DrawDiff Comparison Report

Part number: DA1840189 | Job: 0740fbeb-6c2c-404e-b13b-9dfeb40ea7b0 | Generated: 2026-04-30T02:44:02+00:00

SECTION C-C [MATCHED]

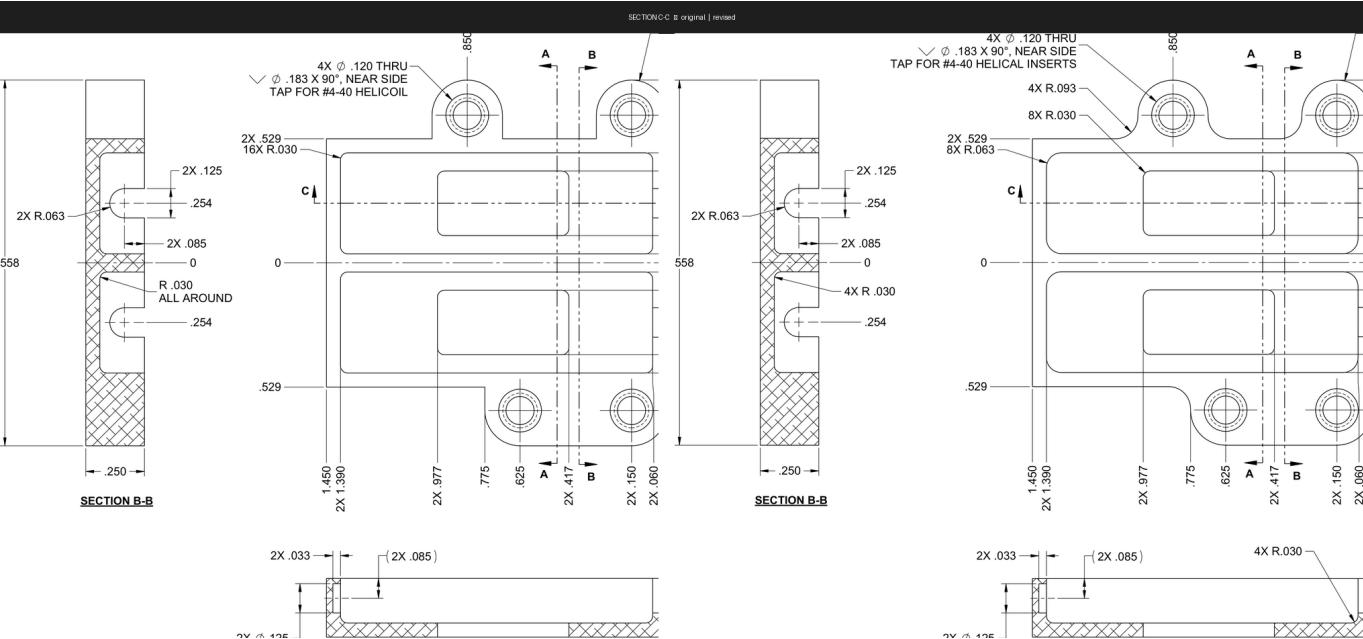
Severity	Field	Original	Revised	Conf.	Rationale
SIGNIFICANT	annotation	16X R.030	8X R.030	0.92	[deduped across views] The count of R.030 radii on the rectangular pockets changed from 16X to 8X, indicating a reduction in the number of corners or locations where this radius applies, which affects machining requirements.
MINOR	note	TAP FOR #4-40 HELICOIL	TAP FOR #4-40 HELICAL INSERTS	0.95	[deduped across views] The thread insert callout wording changed from 'HELICOIL' (brand name) to 'HELICAL INSERTS' (generic term); functionally equivalent but affects procurement/specification language.

ANNOTATION [MATCHED]

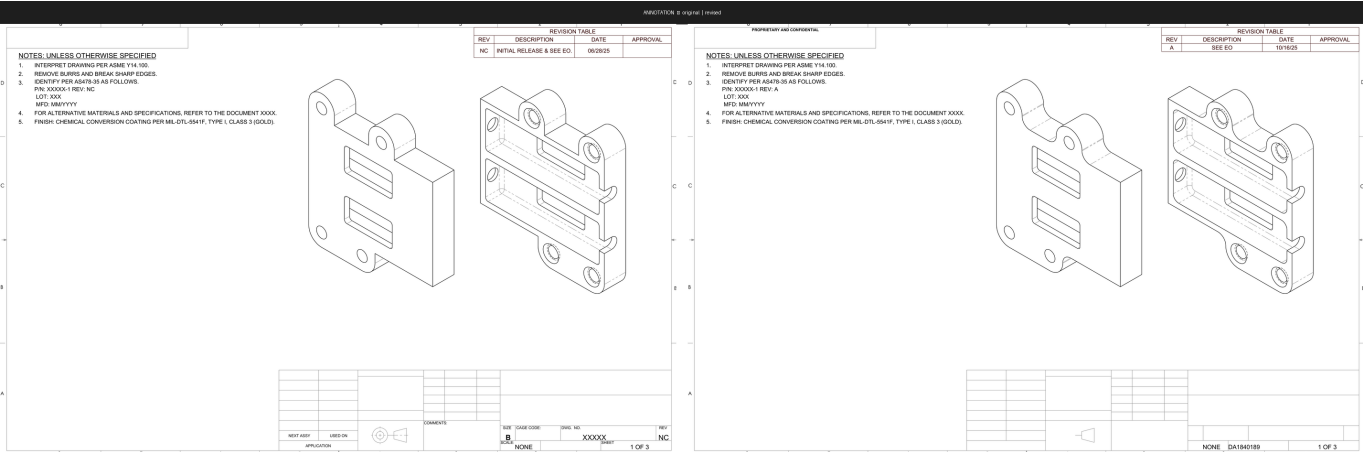
Severity	Field	Original	Revised	Conf.	Rationale
SIGNIFICANT	other	REV: NC INITIAL RELEASE &	REV: A SEE EO 10/16/25	0.97	The revision table has been updated from NC (Initial Release) to Rev A with a new date of 10/16/25, indicating a

Severity	Field	Original	Revised	Conf.	Rationale
		SEE EO. I 06/28/25			formal revision cycle has been initiated.
SIGNIFICANT	note	P/N: XXXXX-1 REV: NC	P/N: XXXXX-1 REV: A	0.97	Note 3 part number identification has been updated from REV: NC to REV: A to match the new revision level in the title block.
SIGNIFICANT	geometry	Front isometric view shows a solid top boss/lug with no visible gap or cutout at the top center of the bracket	Front isometric view shows a gap or cutout visible at the top center of the bracket between the two upper lugs	0.72	The front isometric view of the part appears to show a geometric change at the top of the bracket — the revised view shows what appears to be a cutout or separation between the upper mounting lugs that was not present in the original.
MINOR	annotation	—	PROPRIETARY AND CONFIDENTIAL	0.95	A 'PROPRIETARY AND CONFIDENTIAL' header has been added to the revised drawing that was not present in the original.

ISO_FRONT [MATCHED]

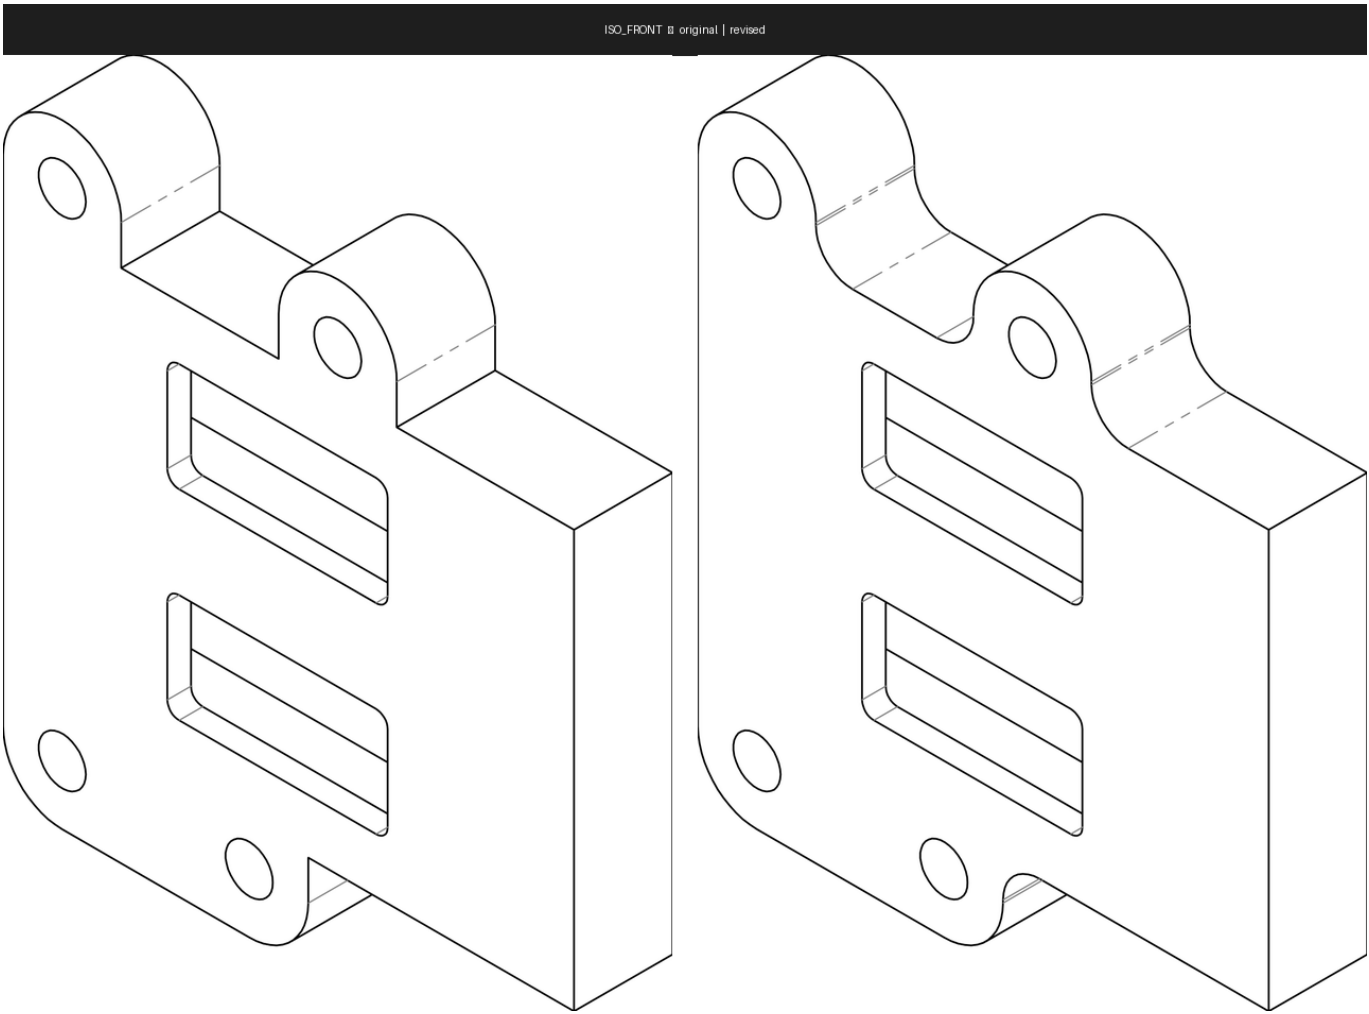
Severity	Field	Original	Revised	Conf.	Rationale
SIGNIFICANT	geometry	Upper flange/tab is a single flat horizontal shelf with a simple curved top edge and no undercut or relief on the underside	Upper flange/tab shows a concave undercut or relief profile on the underside, creating a thinner web between the curved boss and the flat shelf	0.75	The revised view shows a visible concave relief or undercut machined into the underside of the upper mounting flange that is absent in the original, which would affect the structural cross-section and manufacturing operations for that feature.

ISO_REAR [MATCHED]

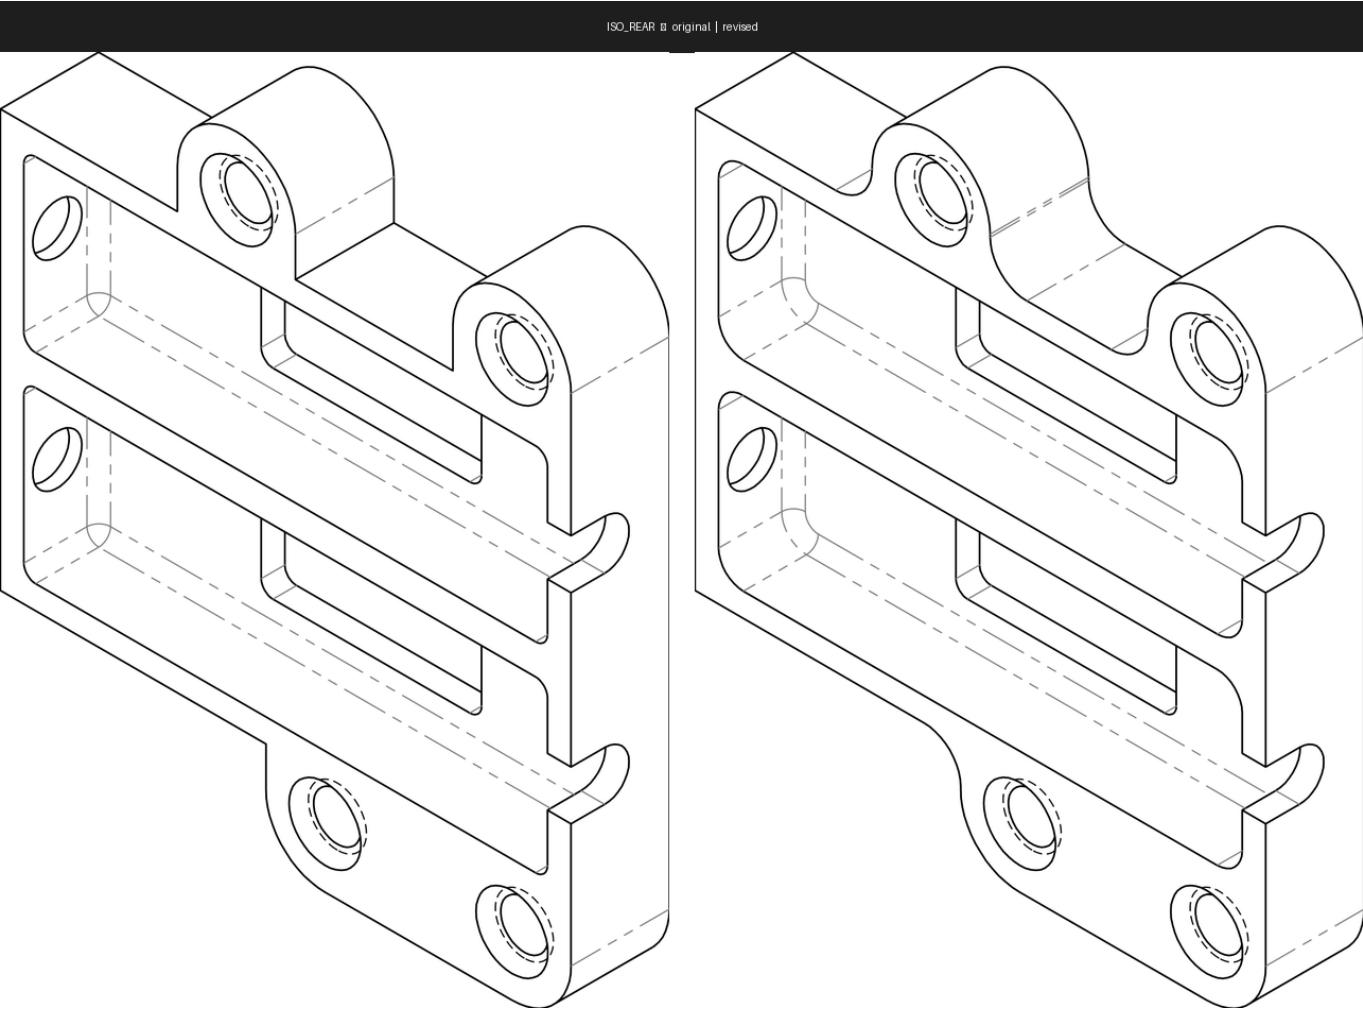
Severity	Field	Original	Revised	Conf.	Rationale
SIGNIFICANT	geometry	Sharp or minimally radiused internal corners at the left-side vertical edges of the upper and lower rectangular pockets/slots (front-left region)	Visibly radiused/ filleted internal corners at the left-side vertical edges of the upper and lower rectangular pockets/slots (front-left region)	0.72	The revised view shows clearly rounded fillets at the internal left-side corners of the two large slot/ pocket features on the front face, whereas the original shows sharp or near-sharp corners, indicating a geometry change that affects stress concentration and potentially manufacturing method.

SECTION A-A [MATCHED]

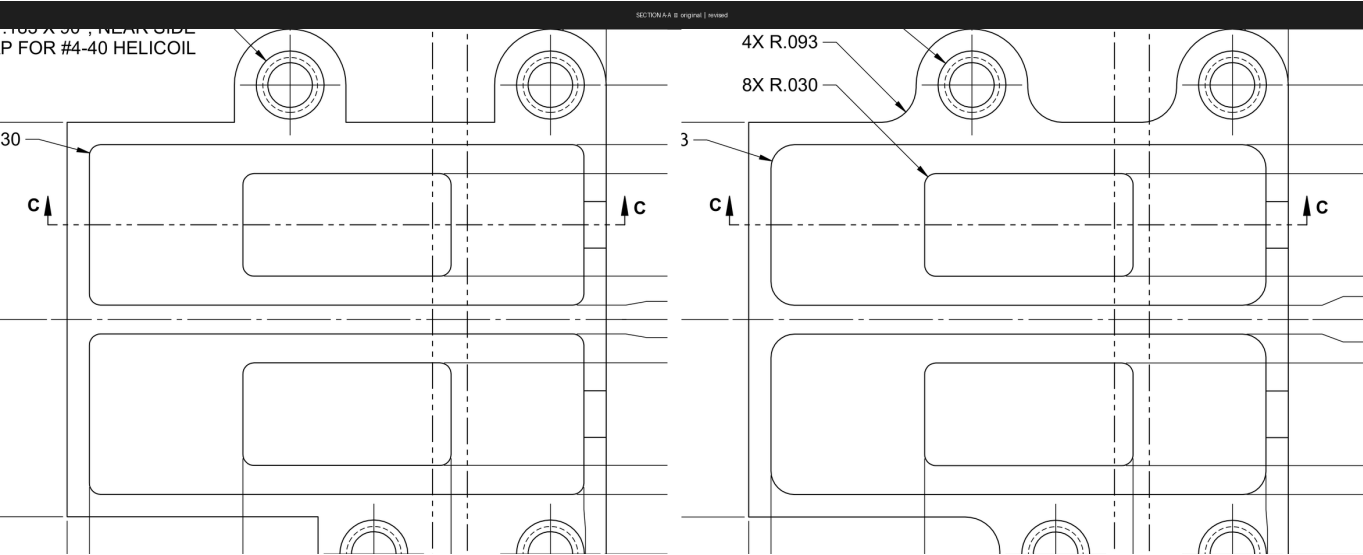
Severity	Field	Original	Revised	Conf.	Rationale
CRITICAL	note	.165 X 90°; NEAR SIDE P FOR #4-40 HELICOIL	—	0.75	The countersink and helicoil preparation note visible in the original ('.165 X 90°; NEAR SIDE / P FOR #4-40 HELICOIL') appears to have been removed from this view in the revision, which would affect thread insert installation requirements.
SIGNIFICANT	annotation	—	4X R.093	0.92	[deduped across views] A new radius callout '4X R.093' has been added in the revised view, specifying four corner radii on the mounting boss features that were not previously annotated.
SIGNIFICANT	dimension	30	—	0.65	A dimension value '30' with a leader arrow visible in the original view appears to be absent or cropped out in the revised view, suggesting a dimension annotation was removed or relocated.

SECTION A-A [MATCHED]

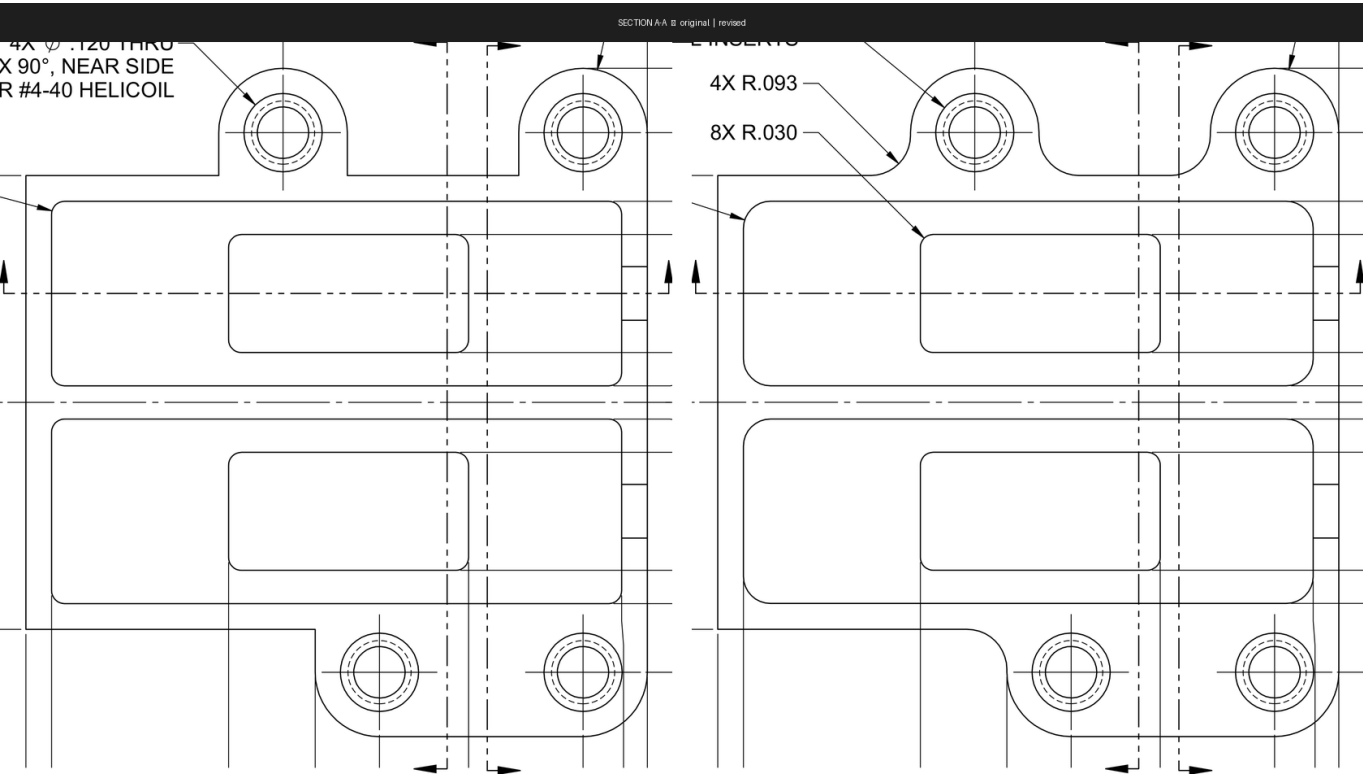
Severity	Field	Original	Revised	Conf.	Rationale
SIGNIFICANT	note	4X Ø .120 THRU X 90°, NEAR SIDE R #4-40 HELICOIL	E INSERTS (partial, truncated at top)	0.72	The hole/helicoil callout text visible in the original ('4X Ø .120 THRU ... #4-40 HELICOIL') appears to have been revised or partially replaced; the revised view shows only a truncated remnant '...E INSERTS', suggesting the note wording has changed, though the full revised text is cut off at the image edge.

SECTION A-A [MATCHED]

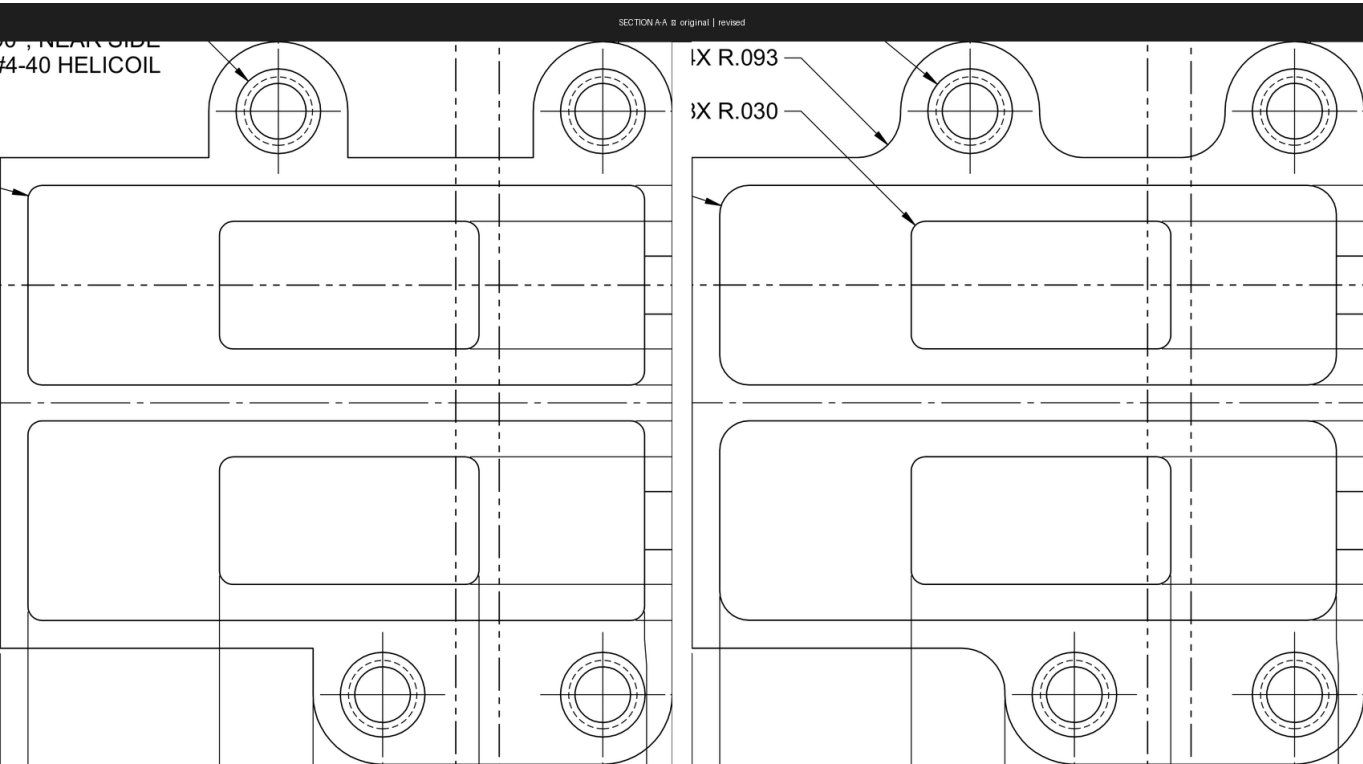
Severity	Field	Original	Revised	Conf.	Rationale
SIGNIFICANT	annotation	—	4X R.093 (with leader to boss fillet radius)	0.88	A new radius callout '4X R.093' with a leader arrow pointing to the mounting boss fillet has been added in the revised view, explicitly specifying a previously uncalled-out radius.
SIGNIFICANT	note	(partial text visible) '...0°, NEAR SIDE' note present in upper left	—	0.72	The partial note visible in the upper-left corner of the original (referencing 'NEAR SIDE' and an angle) has been removed in the revised view, potentially removing a manufacturing instruction.
SIGNIFICANT	geometry	Boss-to-body transition shown as tangent blend (smooth continuous curve)	Boss-to-body transition shown with a more pronounced fillet/step geometry visible between bosses	0.70	The profile of the mounting boss base transitions appears geometrically different in the revised view, showing a more defined step or fillet between the two top bosses, which may reflect an actual geometry change or improved drafting clarity.

SECTION A-A [MATCHED]

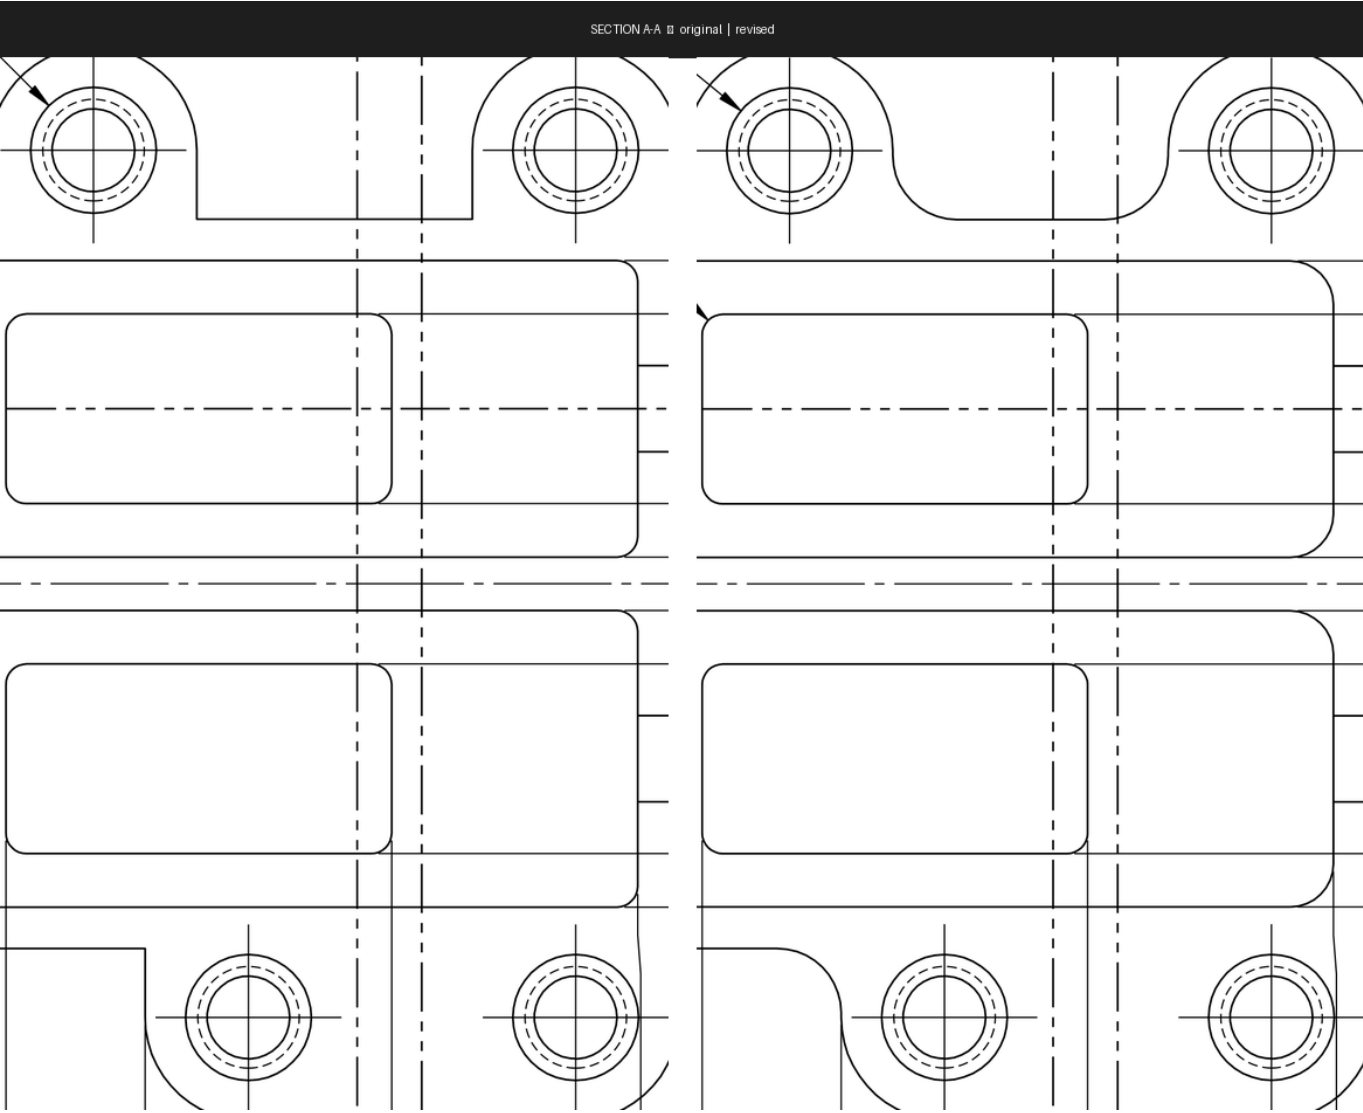
Severity	Field	Original	Revised	Conf.	Rationale
SIGNIFICANT	geometry	Sharp/chamfered corners on central notch between upper mounting bosses	Large radii (fillet) corners on central notch between upper mounting bosses	0.92	The top central cutout/notch transitions from sharp square corners to large rounded fillet corners, significantly changing the geometry and stress distribution at those transitions.
